**AFSAR**  
DEVELOPERS

August 28, 2025

Ref: BOT 25-01; 1308 -1330 S. Meyers Road

Below are the responses to the key questions raised during the August 21, 2025 Village Board meeting.

Figure 1: February 16 Plan – 79 ft Width

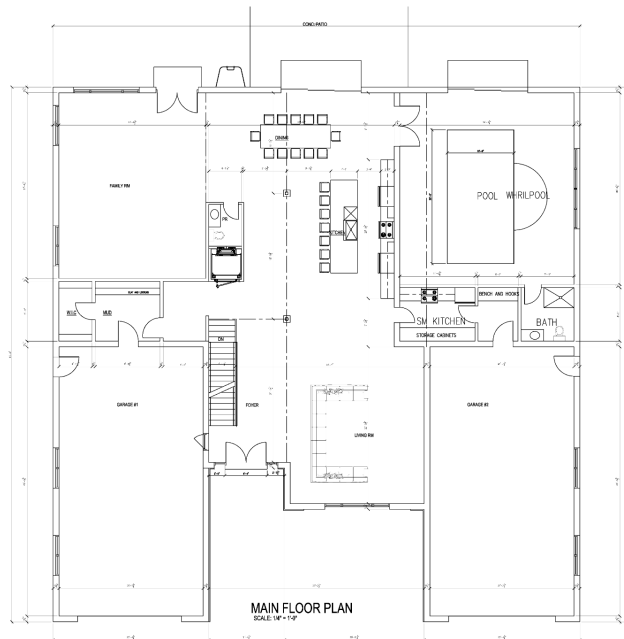
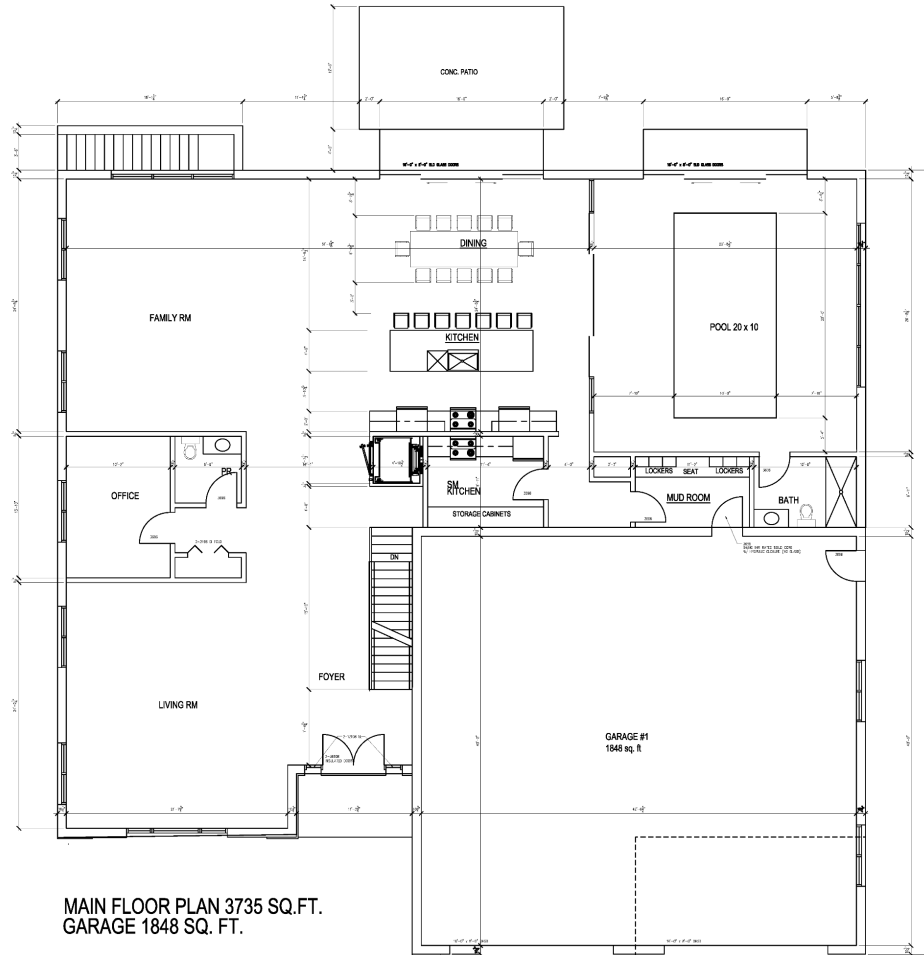
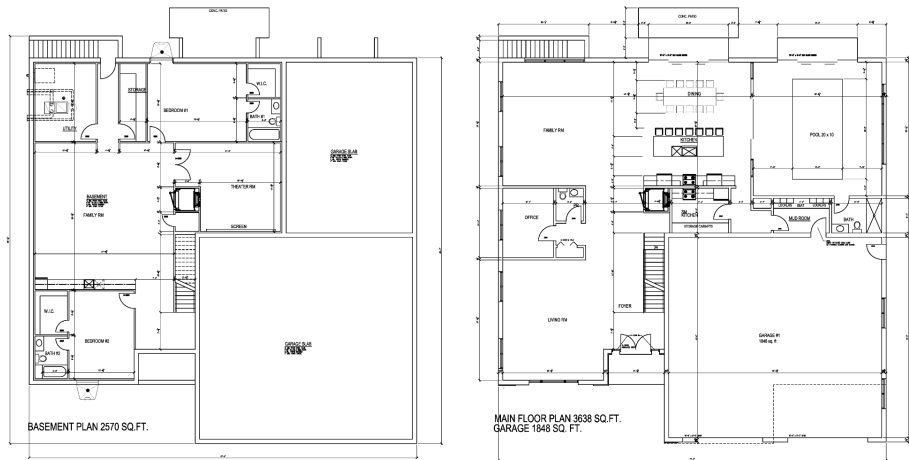
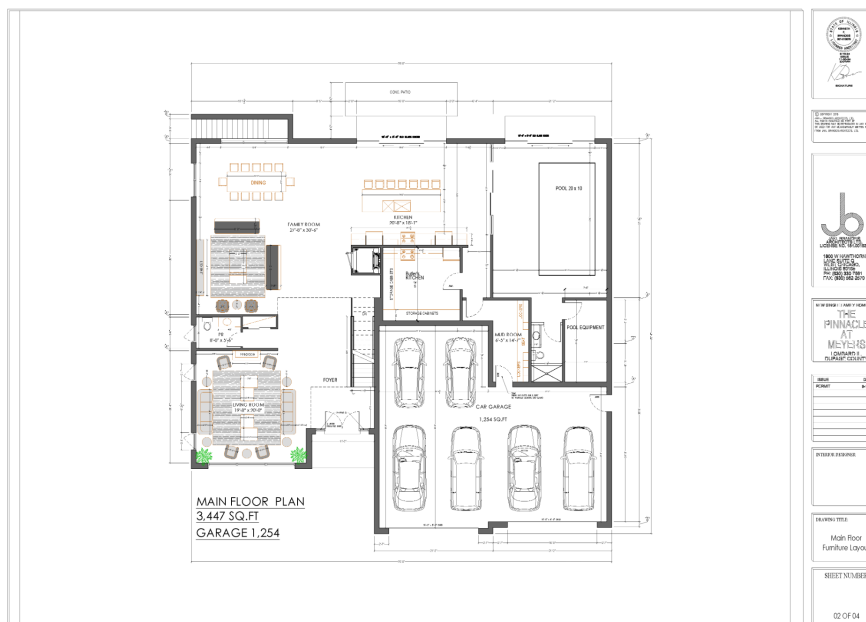
### 3. Internal changes implemented to ensure Open Space variance request does not change

We conducted multiple internal revisions to reduce the home footprint.

- The original plan (consolidating 4 of 22 lots) featured 79-foot-wide homes (February 16 layout).
- Through March 20 and March 26 iterations (78'-10" and 77'-6" respectively), we progressively reduced this dimension.
- The current plan now features 75-foot-wide homes, maximizing efficient layouts while respecting open space goals.

Figure 5: 22 Lot Plan – 7,100 sq ft Average

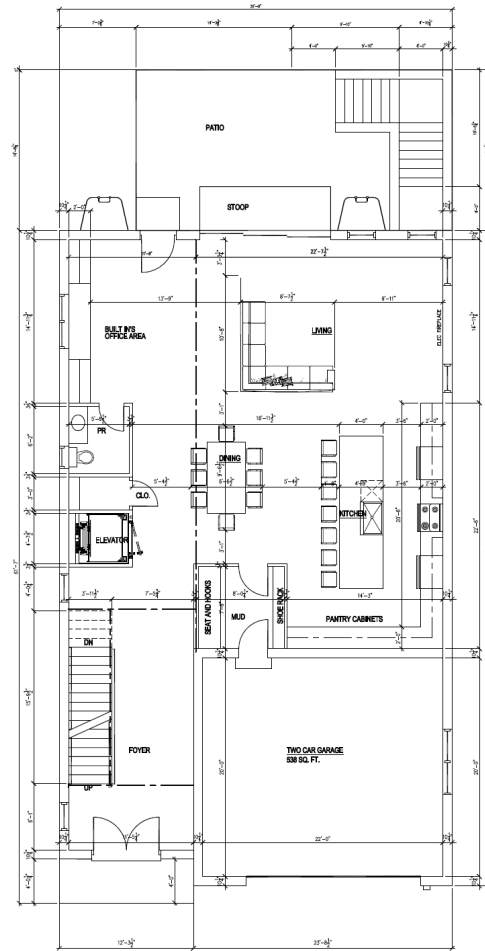
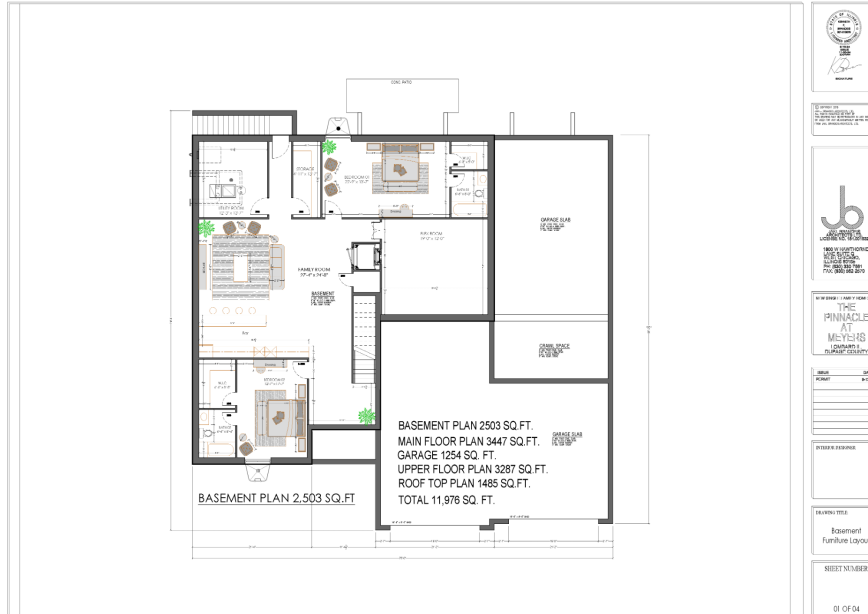
#### 4. Total Sq. Ft. Comparison

As requested during the hearing, below are comparisons of total square footage of the previous and current homes:

- The prior 22-lot plan included homes averaging roughly 7,160 sq ft each (6,618 + 538 garage).
- The current 11-lot plan features larger homes averaging 12,000 (10,722 + 1,254 garage) sq ft each—halving density while preserving open space and improving building separation.
